WALDEN PRESERVE
FILING NO. 5
Construction Drawings
El Paso County, Colorado

WALDEN PRESERVE 2 - FILING NO. 5

WALDEN PRESERVE 2 FILING NO. 5 Grading & Erosion Control Plans El Paso County, Colorado

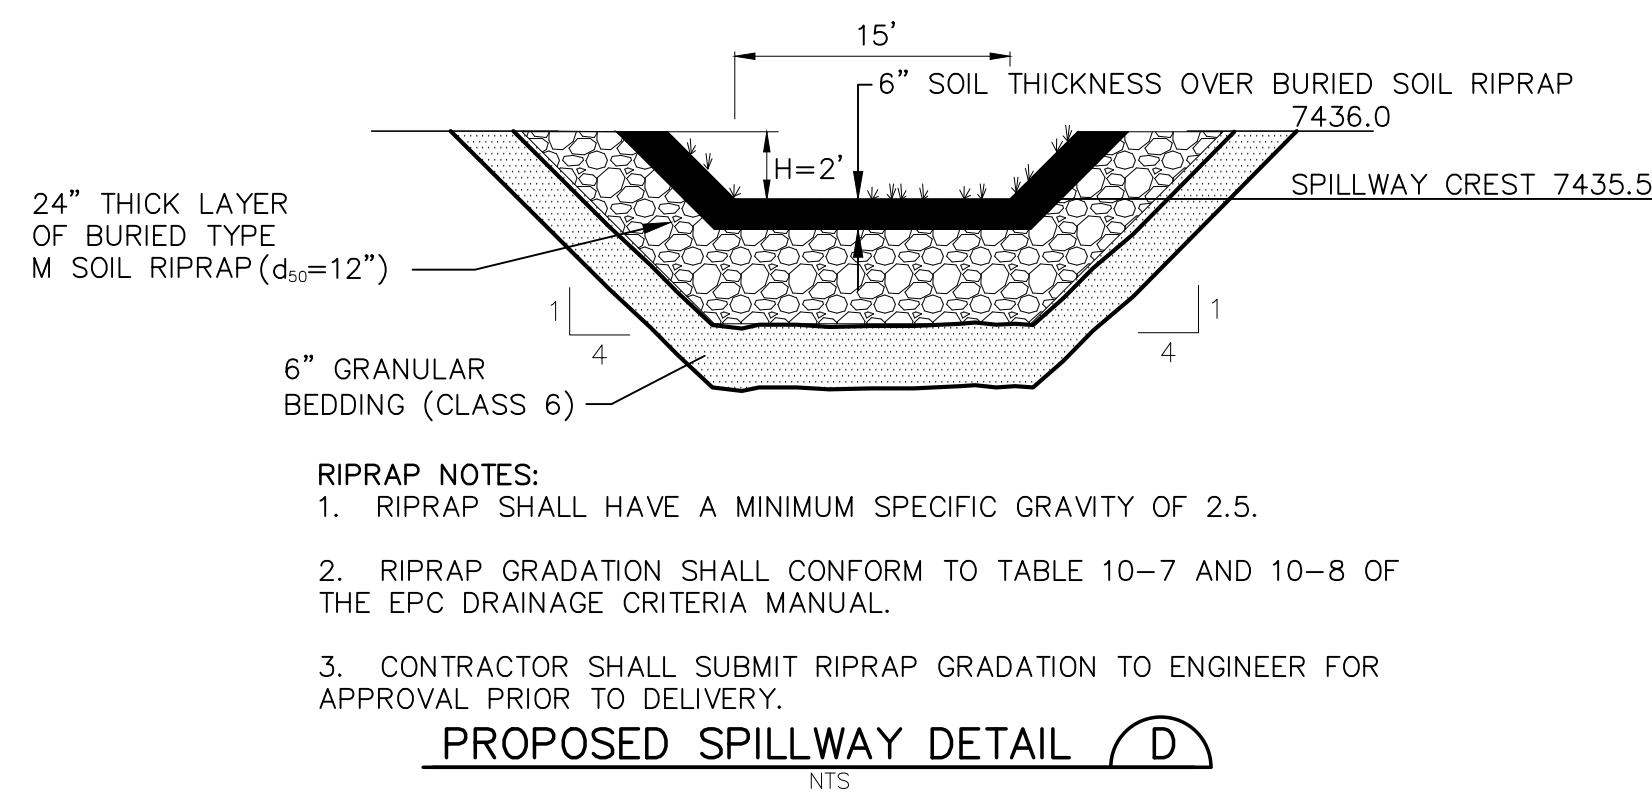
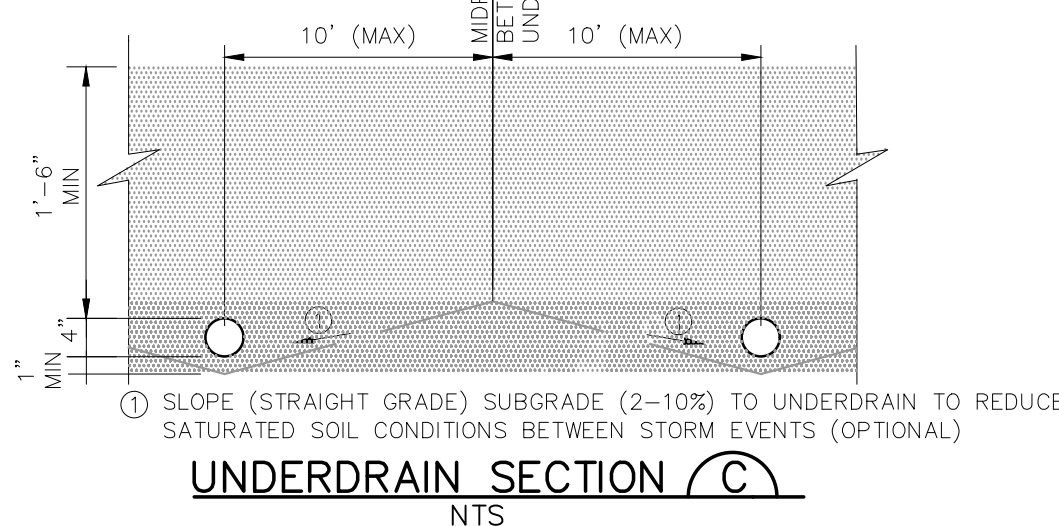
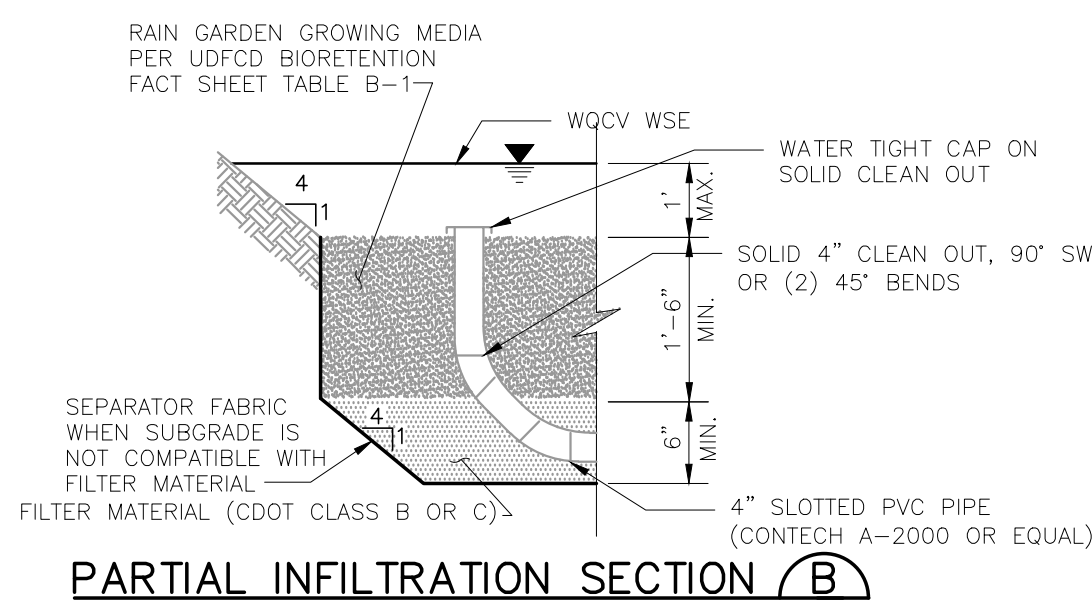
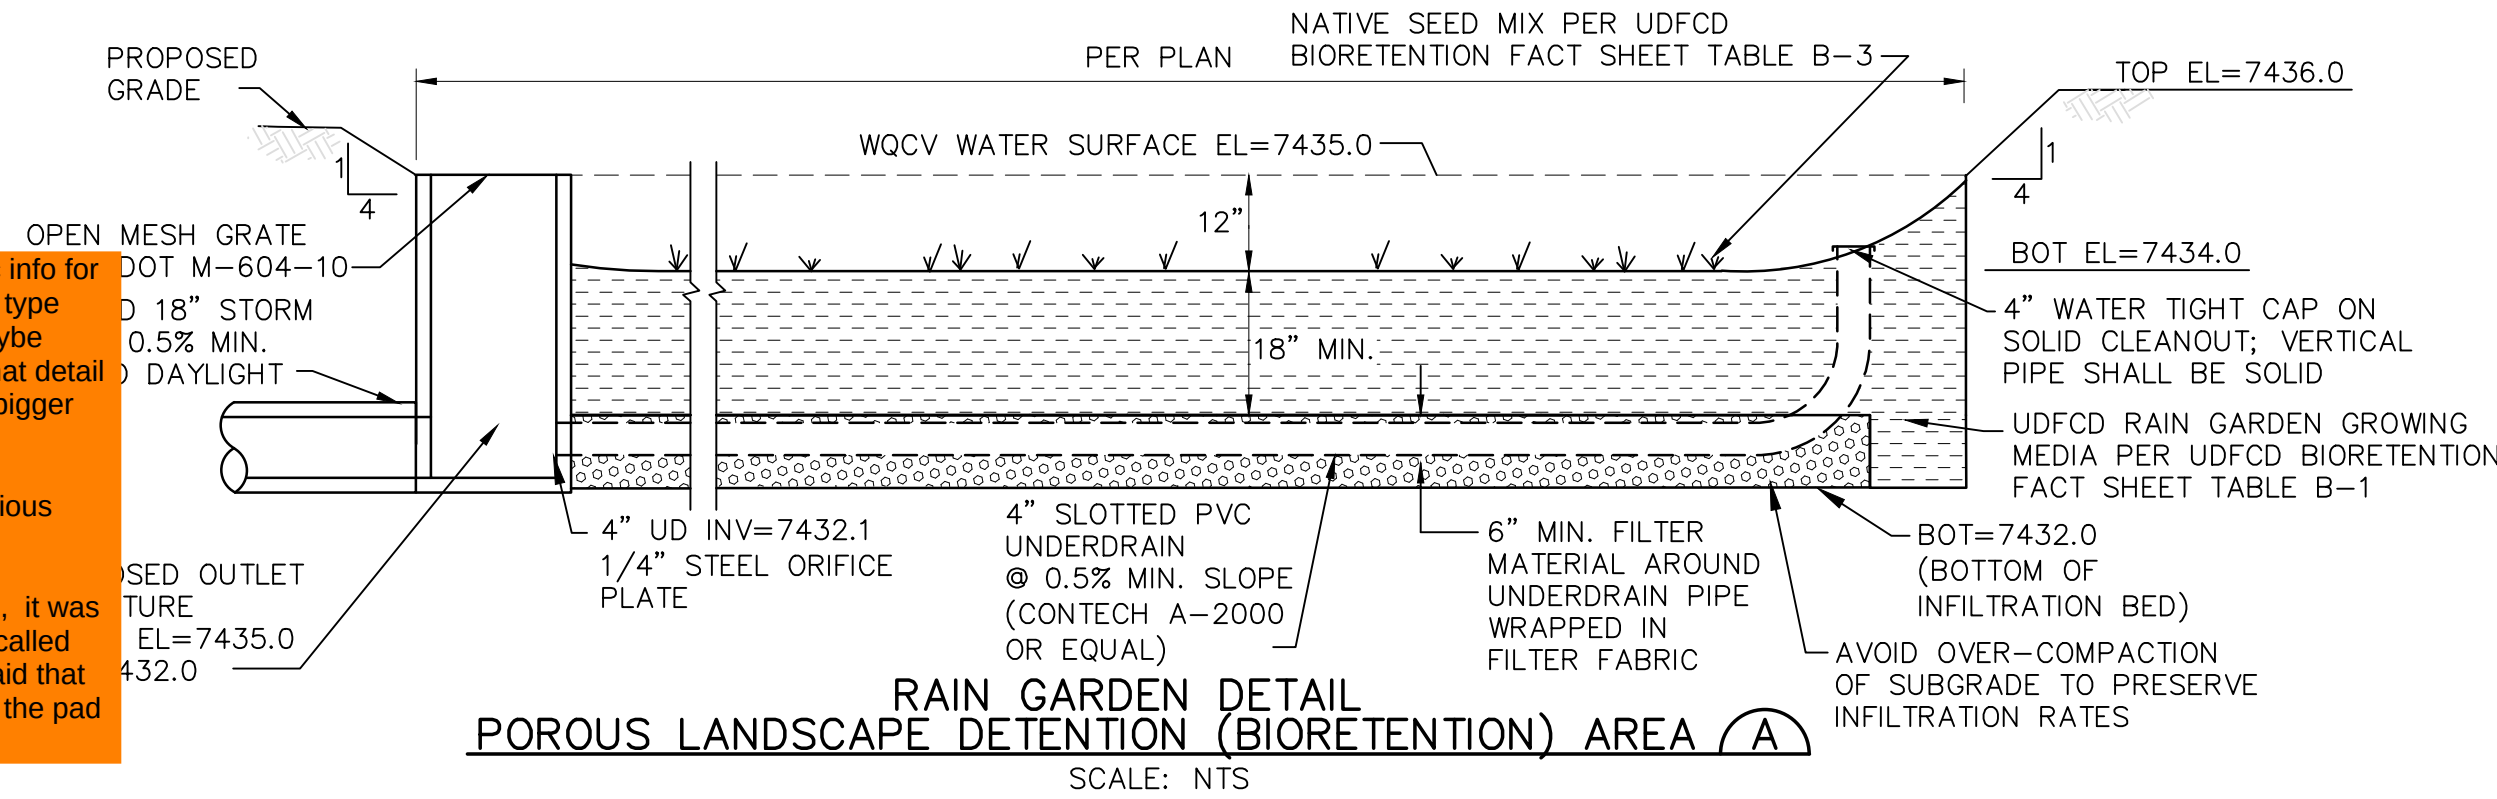
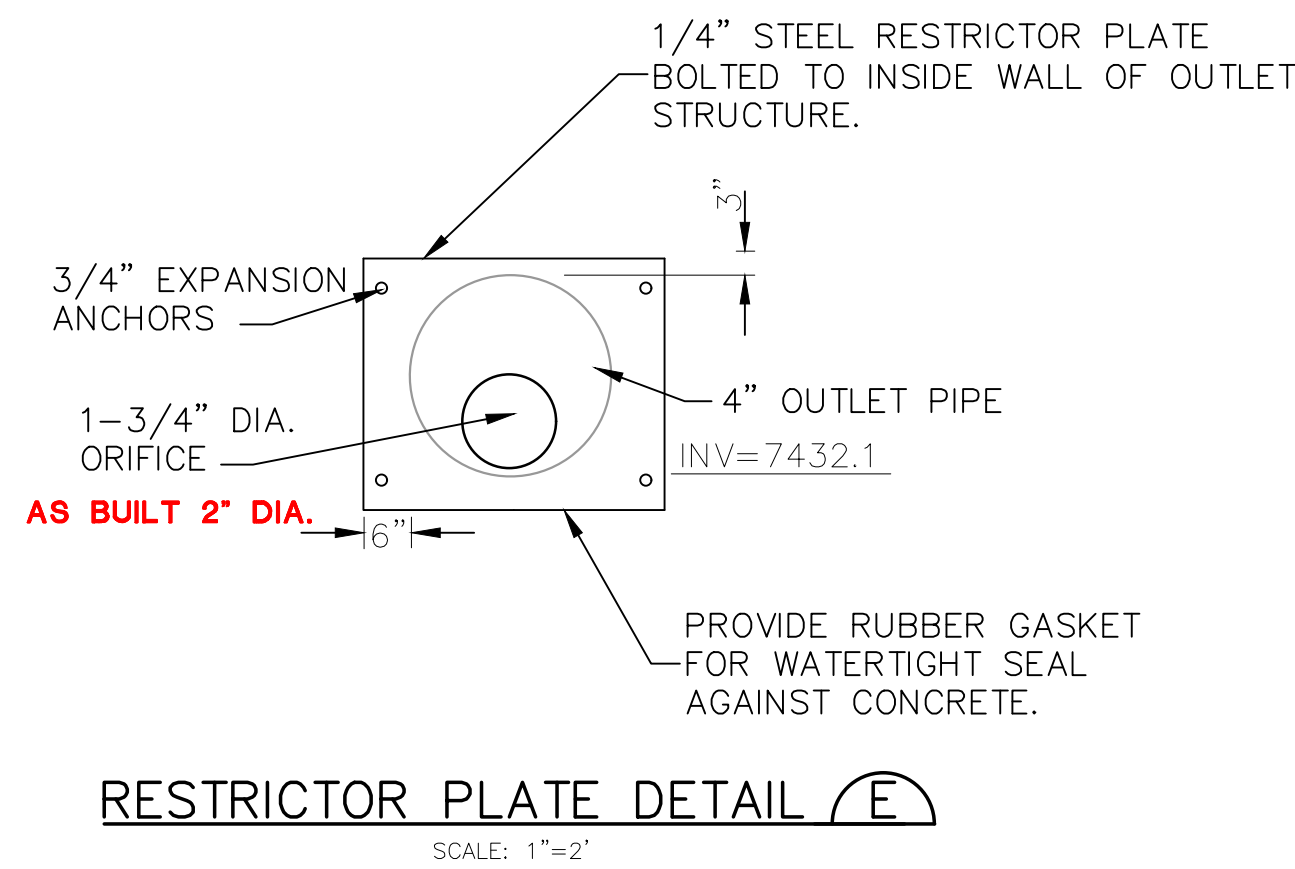
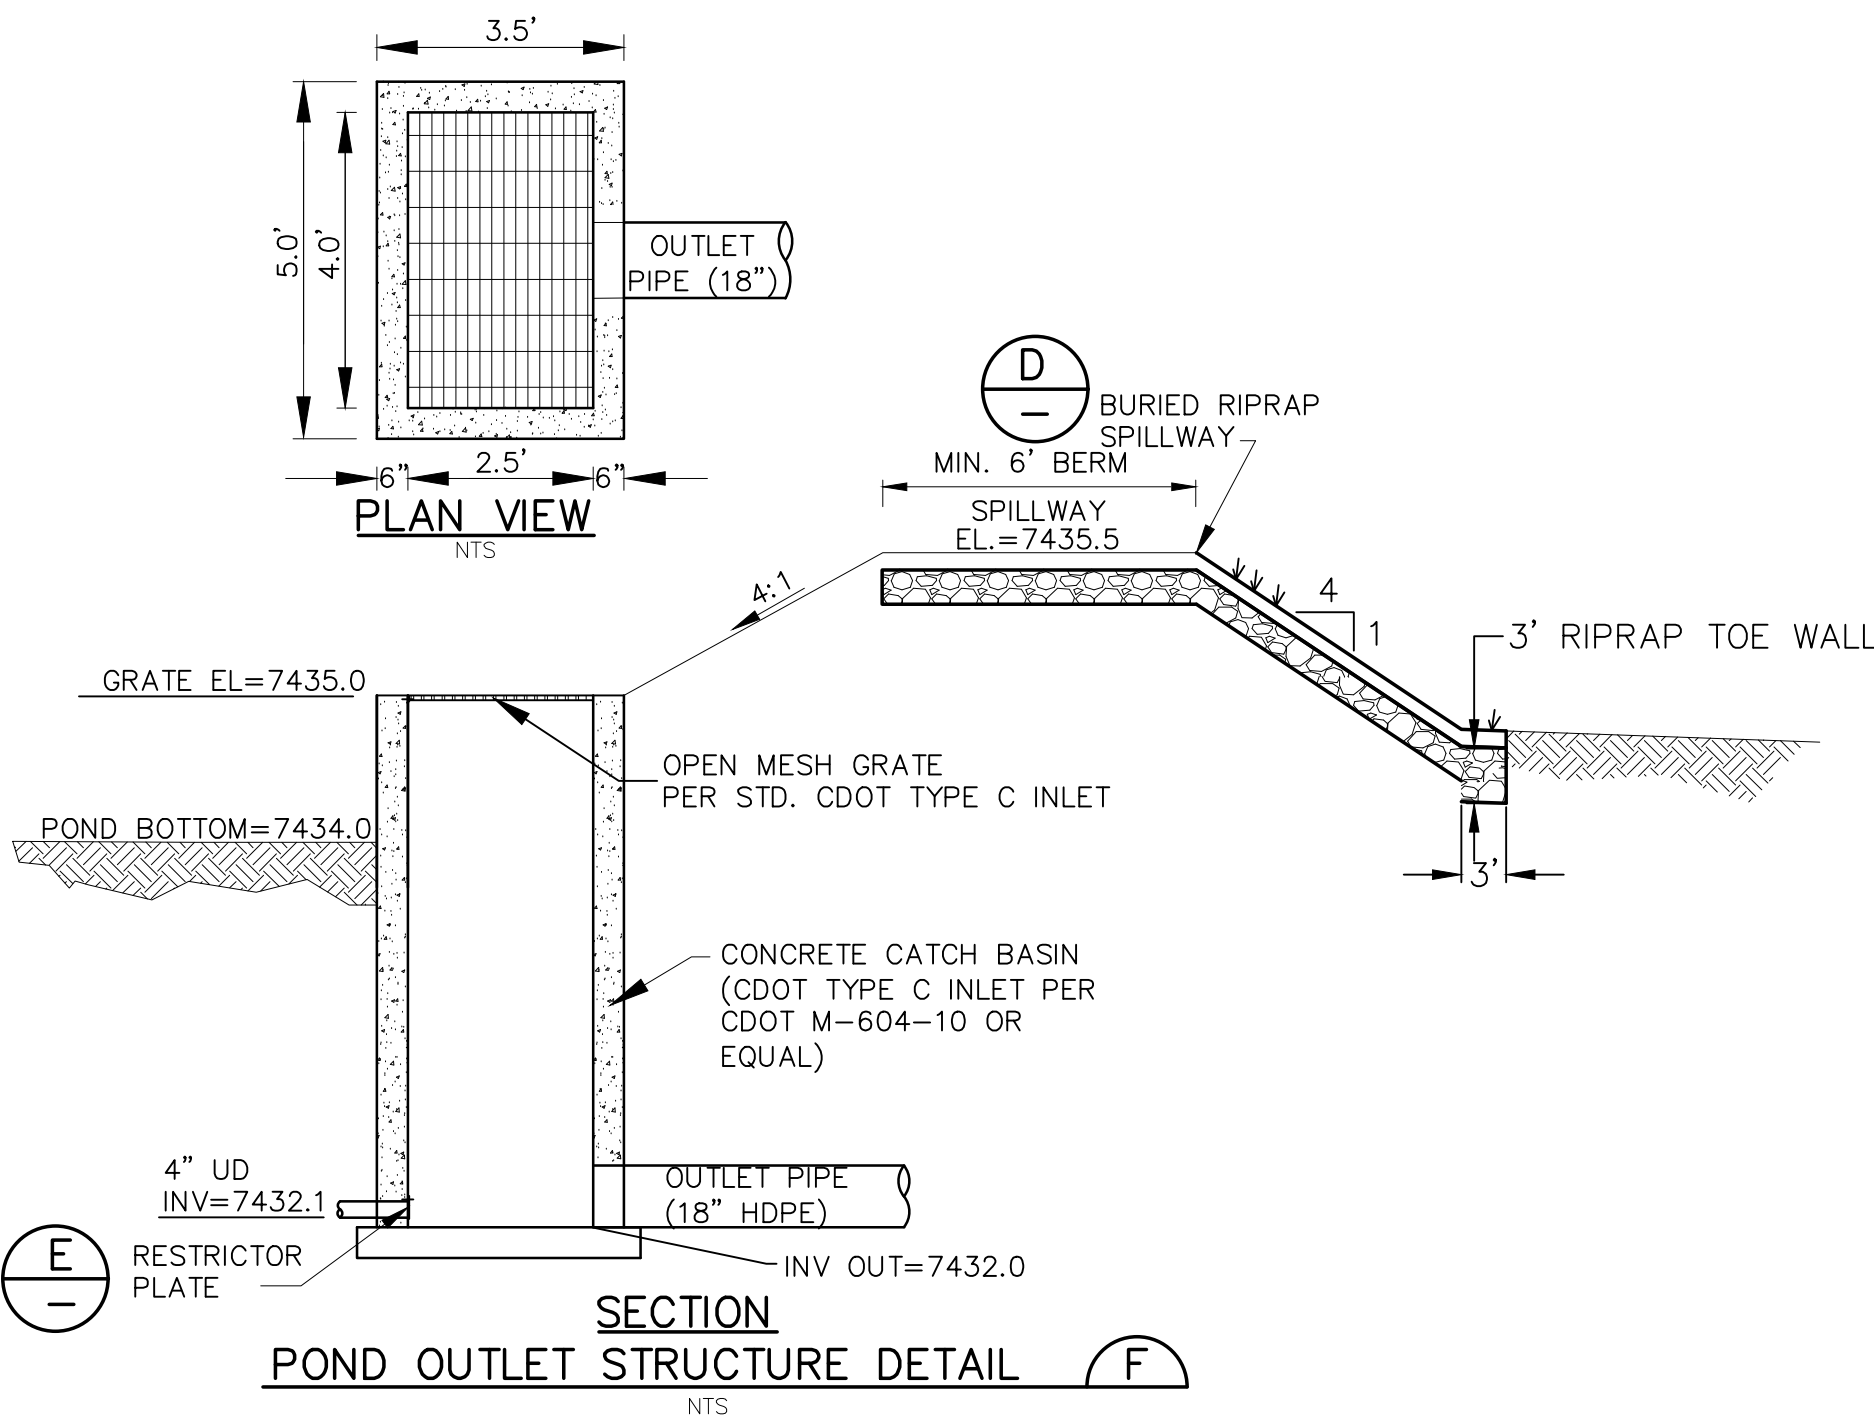
I don't understand how this detail provides any specific info for this riprap apron. Wouldn't you need to callout a riprap type here for that reference table to be helpful? Did you maybe mean to reference Detail C on sheet TY1. If you did, that detail calls out Type M and I think the riprap in the field was bigger than that.

And for reference, below is my comment from the previous review:

For the apron at the downstream end of the outlet pipe, it was installed in the field, but just with larger rock than was called out on plans and didnt have positive drainage. Shay said that they would fix the positive drainage and dimensions of the pad in the field and that the rock size would be as-built.
